UNITED STATES PATENT AND TRADEMARK OFFICE

APPLICATION NO.	FILING DATE	FIRST NAMED INVENTOR	ATTORNEY DOCKET NO.	CONFIRMATION NO.
10/789,078	02/27/2004	Steven J. Wygant	BEL0005.US	7269

Office Action Summary	Application No.	Applicant(s)	
	10/789,078	WYGANT, STEVEN J.	
	Examiner	Art Unit	
	Troy Chambers	3641

DETAILED ACTION

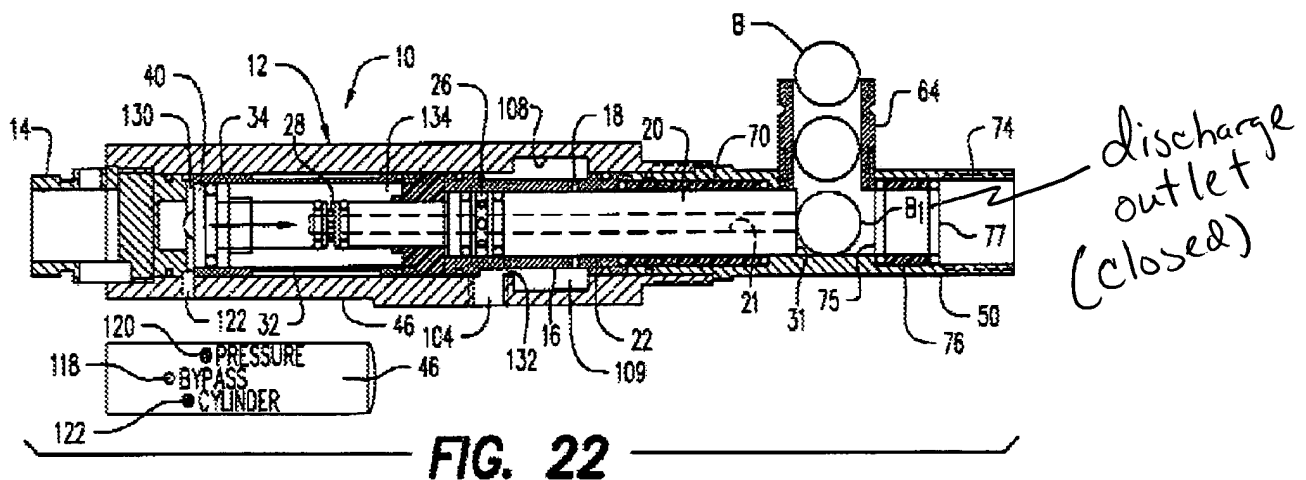
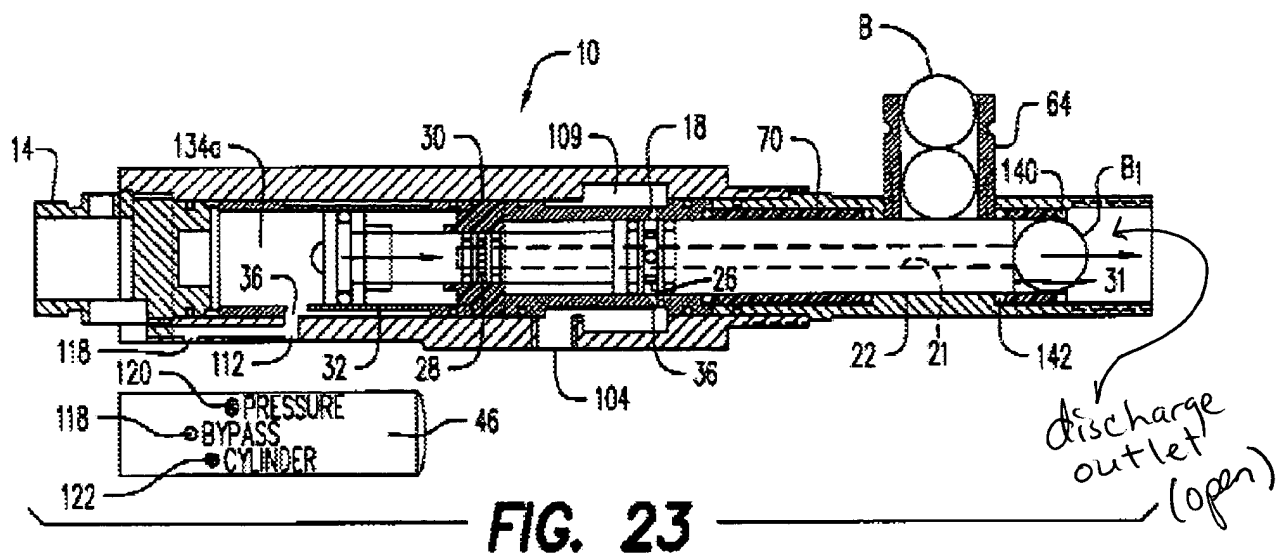
2. Claims 1-5, 7-9 and 12-14, 17, 18 and 20-22 are rejected under 35 U.S.C. 102(b) as being anticipated by U.S. 5769066 issued to Schneider. Schneider discloses a pneumatic shooting device 10.

3. With respect to claim 1, Schneider discloses a pneumatic shooting device comprising:

- a. a barrel 72;
- b. an action including:
 - i. a housing 12,
 - ii. a pressure reservoir 109,
 - iii. a discharge outlet see Fig. above
 - iv. a linear body 32,
 - v. a piston 40.

Upon return of the piston to the reward position, the discharge outlet is closed to a source of pressurized gas (col. 5, ll. 66 to col. 6, ll. 6).
